PLANNING AMENDMENT DRAWING: 04.03.2024

18 No. - 2B Apartments,
Aspinall Street, Prescott, L34 5QQ.

Proposed Elevations (2 of 3)

DRAWING NUMBER	REVISION	DATE
4188 / SK 07	H	May 2022
		SCALE 1:100 @ A3

PROPOSED APINALL STREET (WEST) ELEVATION

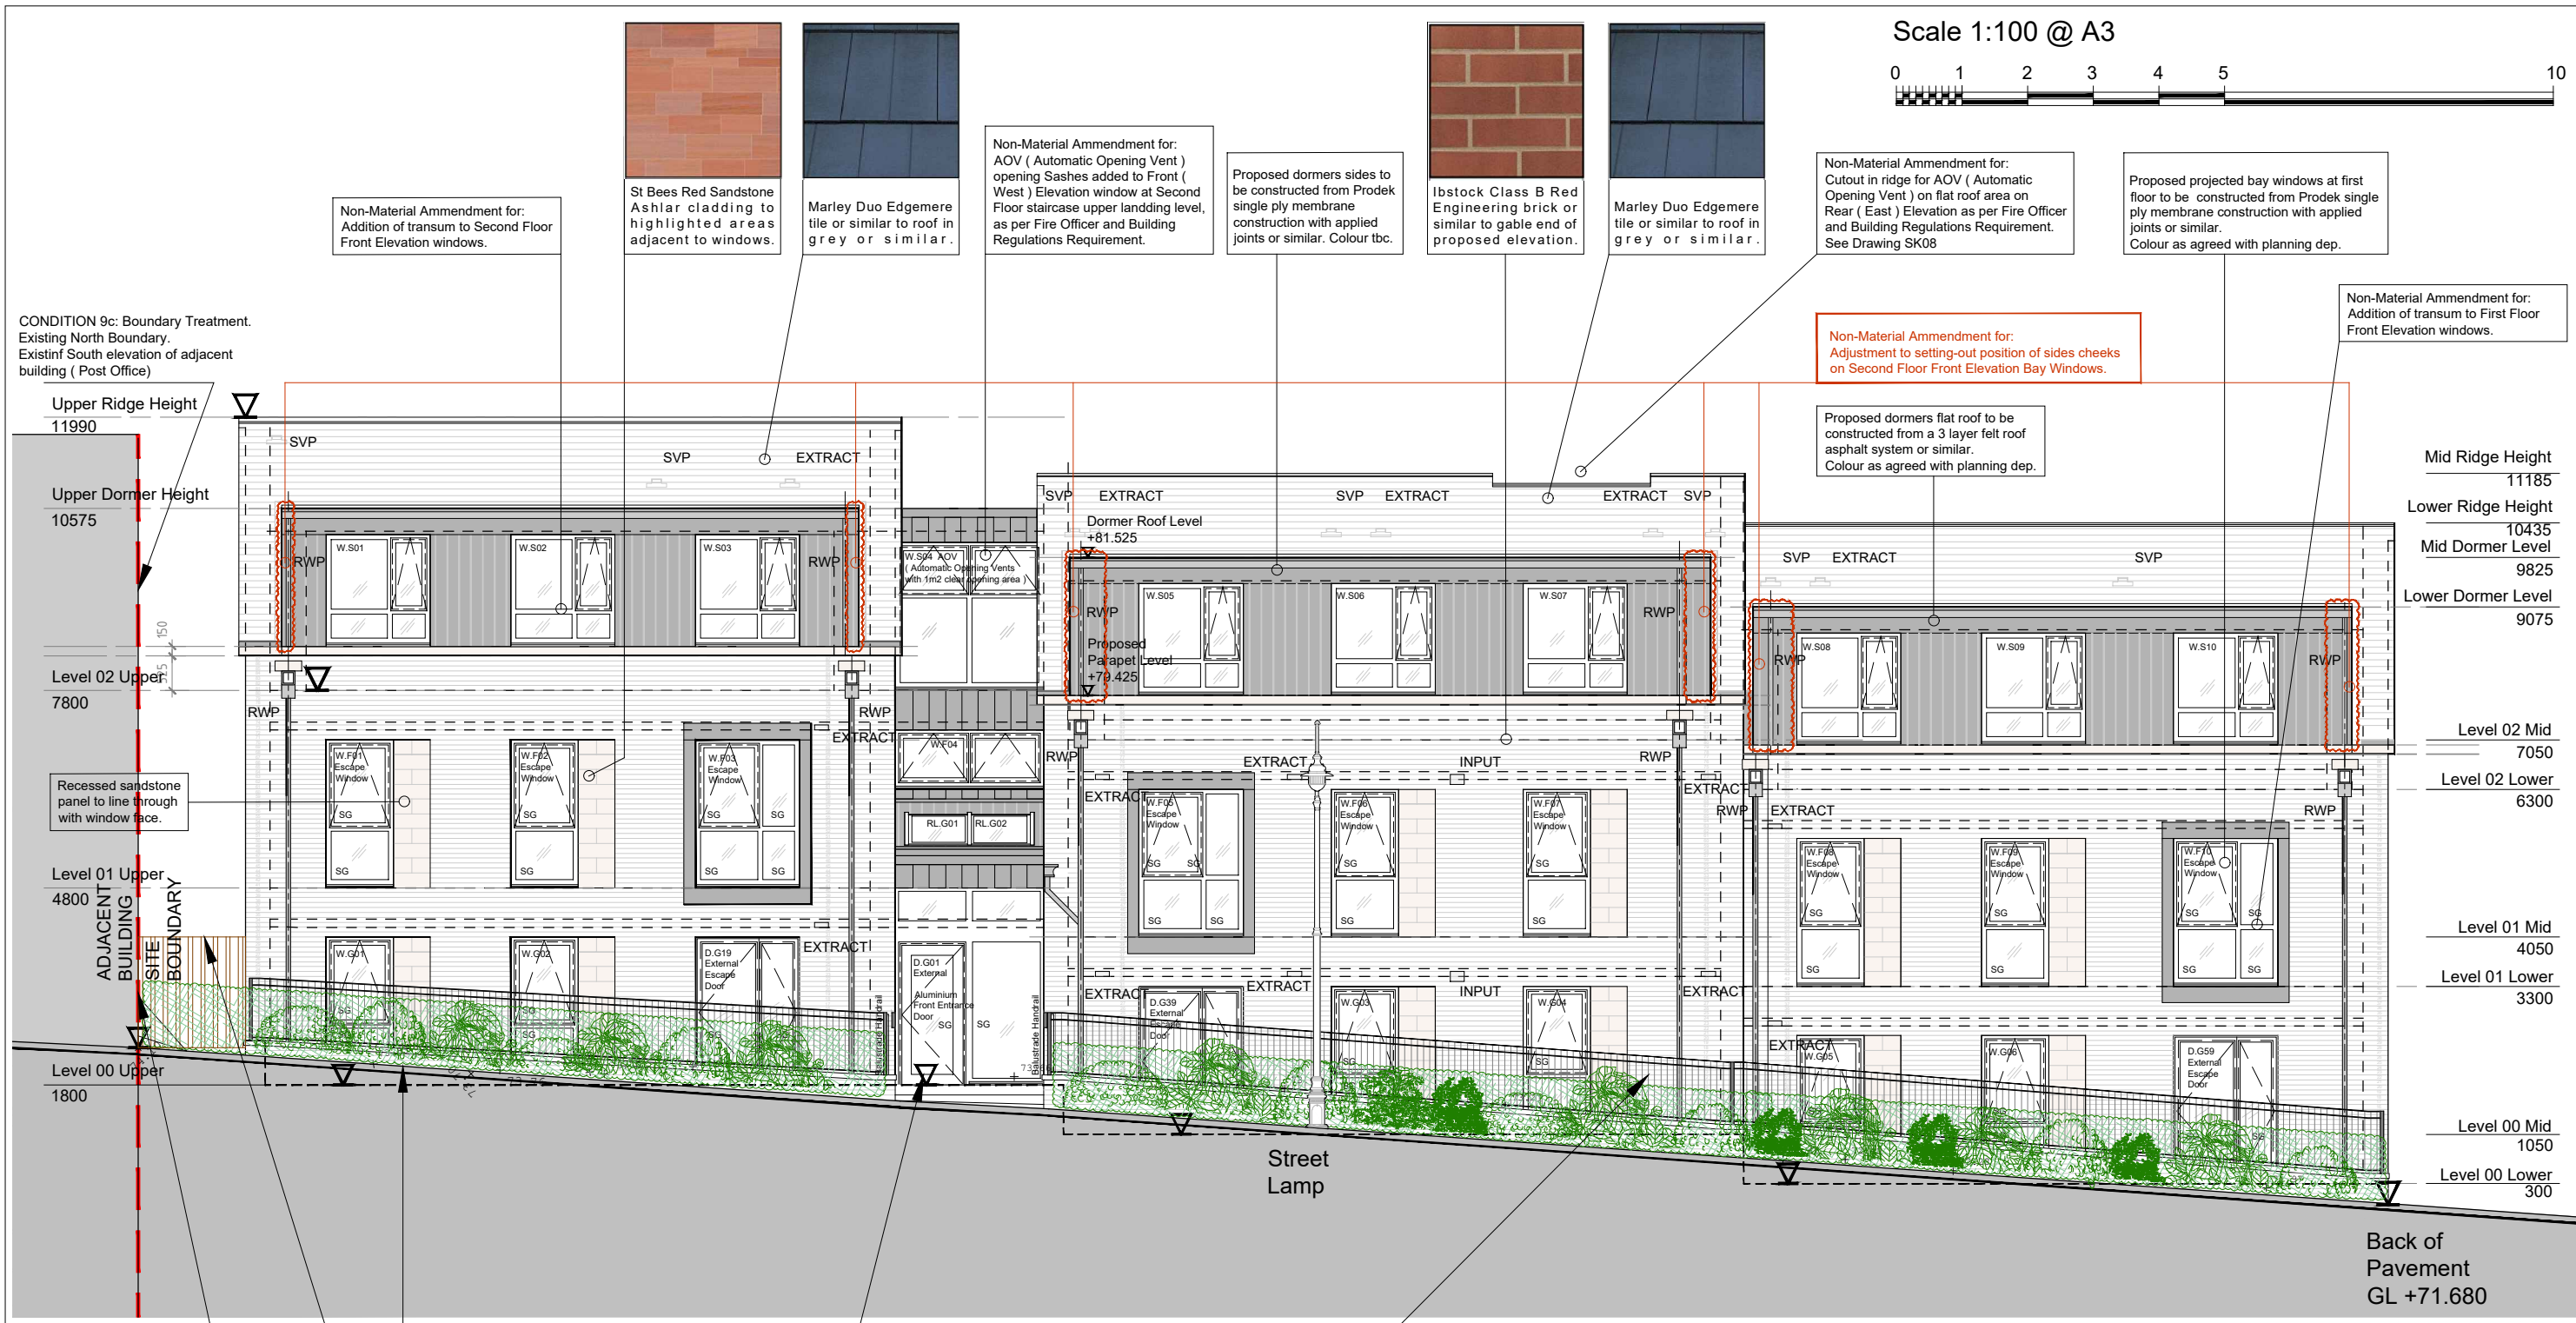
CONDITION 9c: Boundary Treatment. Existing Boundary at North West Corner. Existing low level brickwork wall and handrail of adjacent building (Post Office) entrance steps to be retained.

CONDITION 9c: Boundary Treatment. 1800mm high paint finished / stained timber fence, to close gap between building and North Site Boundary / Post Office Building. Fence as per Bin Storage compounds construction.

CONDITION 12: Closure of existing Northern Entrance. CONDITION 9a: Hard Landscaping Redundant site entrance. Existing radiused kerbs to be removed. New road kerb and paved footpath "match existing" to be laid level with existing paving. All materials and works to highway officers approval.

CONDITION 9c: Boundary Treatment Hard Landscaping Stepped approach to Front (Main) Entrance. Brick faced steps with conc paving treads and handrail. Steps to be in accordance with Part M and have max. rise of 150mm and 300mm tread. Handrail at 900mm above string line with 300mm oversail past steps.

CONDITION 23. Secure Entry System Secure entry system door locks on Front and Rear Doors.

CONDITION 9c: Boundary Treatment New East Site Boundary - Aspinall Street:

Retaining wall and Railing Brick faced terrace wall with capping and paint finished metal railing. Brickwork as per new buildings wall elevations. Flat ms bar railing with second bar at 100mm below top edge. Vertical spindles at max. 100mm cts.

Soft Landscaping New topsoil & Soft Landscaping area with planting along South Site Boundary, to Landscape Architects detail, schedule. Conc. edging strip to along existing back of paving.

H	04.03.24	Non-Material Ammendment for: Adjustment to setting-out position of side cheeks on Second Floor Front Elevation Bay Windows.
